November 2011

NMB 4715KL Fan Series Part Numbering Change Notice

Flange Type: P00 to E00

Fan Stator Assembly Design Improvement

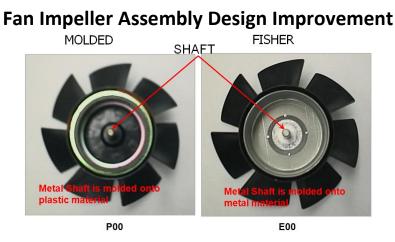
P00 = 50K hrs. vs E00 = 100K hrs.

- Same Mechanical - No changes in Dimensions
- This change is basically a design improvement and no changes in form, fit, and function. Both series have the same electrical and mechanical characteristics.
- This change is a positive one. The E series impellers / stators assembly are more robust construction and provide greater shaft stability than the old P series.
